HISTORIC AND DESIGN REVIEW COMMISSION

HDRC CASE NO: 2022-173
ADDRESS: 3618 MCCULLOUGH AVE
LEGAL DESCRIPTION: NCB 7054 BLK 1 LOT 3 (ADAMS - AYRES OF MONTE VISTA SUBD)
ZONING: R-5, H
CITY COUNCIL DIST.: 1
DISTRICT: Monte Vista Historic District
APPLICANT: Virgilio Aguilar/Don B. McDonald JR. Architects Ltd
OWNER: Madeline Maxham/OCP JCG LANDA LLC
TYPE OF WORK: New construction of a 2-story residential structure
APPLICATION RECEIVED: March 18, 2022
60-DAY REVIEW: Not applicable due to City Council Emergency Orders
CASE MANAGER: Rachel Rettaliata
REQUEST:

The applicant is requesting conceptual approval to construct a new 2-story, single-family residence at 3618 McCullough.

Site + Roof Plan

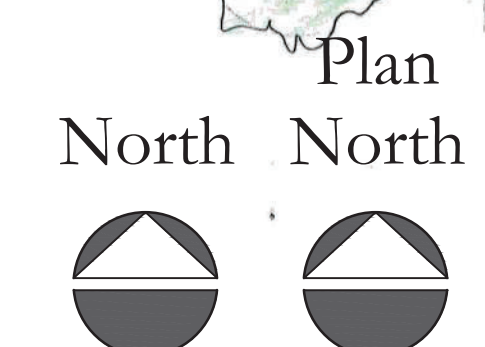
- k. **DRIVEWAYS** – Guideline 5.B.i for Site Elements notes that new driveways should be similar to those found historically within the district in regard to their materials, width, and design. Additionally, the Guidelines note that driveways should not exceed ten (10) feet in width. The applicant has proposed to install a curb cut on the west side of the property off of McCullough. It is unclear from the site plan if the applicant is proposing a new curb cut or utilizing the existing curb cut. Staff recommends that the applicant submits a site plan showing adjacent properties and provides dimensions and materials for the proposed curb cut and driveway.

- l. **SITE WORK** – The Guidelines for Site Elements note that front yard walkways and site work should appear similar to those found historically within the district in regard to their materials, width, alignment and configuration. At this time, the applicant has not submitted a comprehensive plan for site work, but has indicated that West Texas Crème Limestone is proposed to be installed for new site walls, paving, and steps, and that 3/8” pea gravel on 6” decomposed granite is proposed for pathways. Staff finds that the applicant should submit a comprehensive site plan for review of site work prior to returning to the HDRC.

- iv. That the applicant submits a site plan and landscaping plan detailing all proposed site work and landscaping modifications to staff for review based on findings k through n.

Exterior Elevation

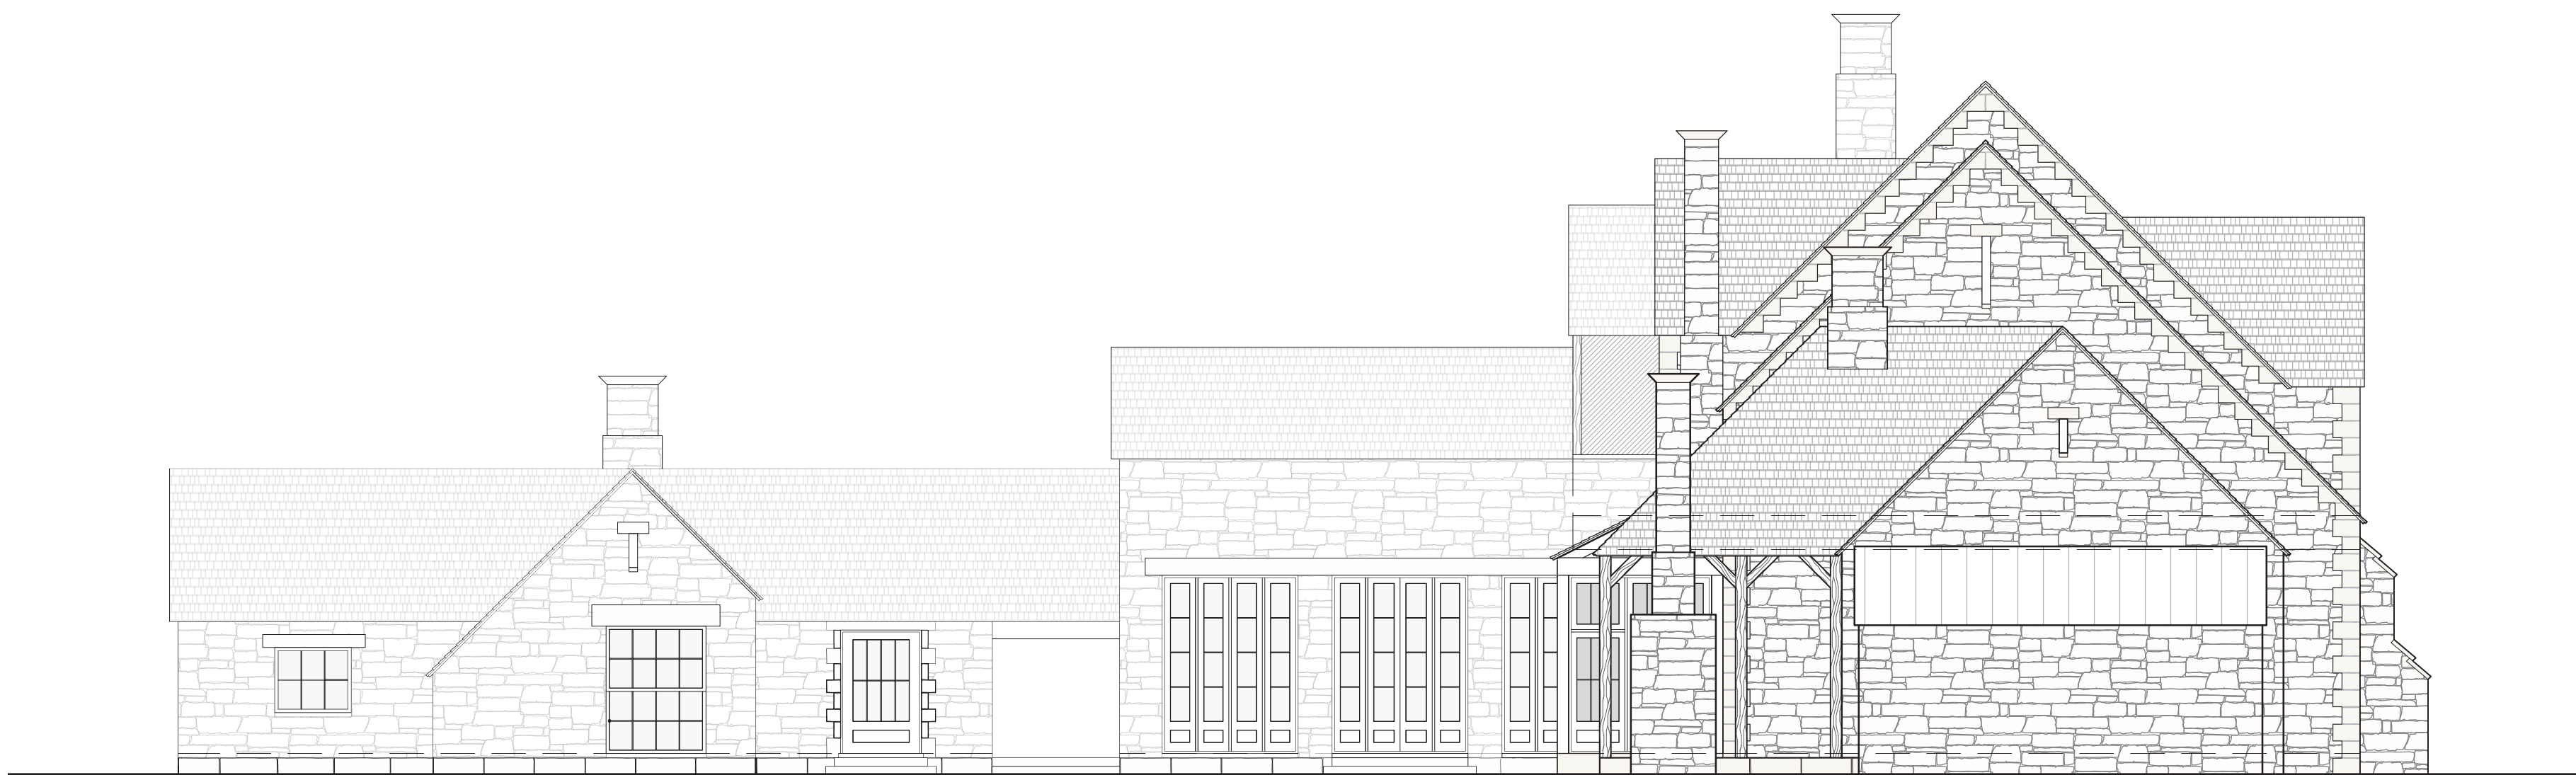
- e. ROOF FORM – The applicant has proposed a side gable roof with a projecting front gable and decorative gables. According to Guideline 2.B.i for New Construction, new construction should feature roof forms that are consistent with those predominantly found on the block. The adjacent structures on McCullough feature front gable, cross gable and hip roof forms. Staff finds the proposal consistent with the Guidelines.

- i. **RELATIONSHIP OF SOLIDS TO VOIDS** – Guideline 2.C.i for New Construction stipulates that new construction should incorporate window and door openings with a similar proportion of wall to window space as typical with nearby historic facades. Windows, doors, porches, entryways, dormers, bays, and pediments shall be considered similar if they are no larger than 25% in size and vary no more than 10% in height to width ratio from adjacent historic facades. Staff finds the proposed fenestration pattern generally appropriate.
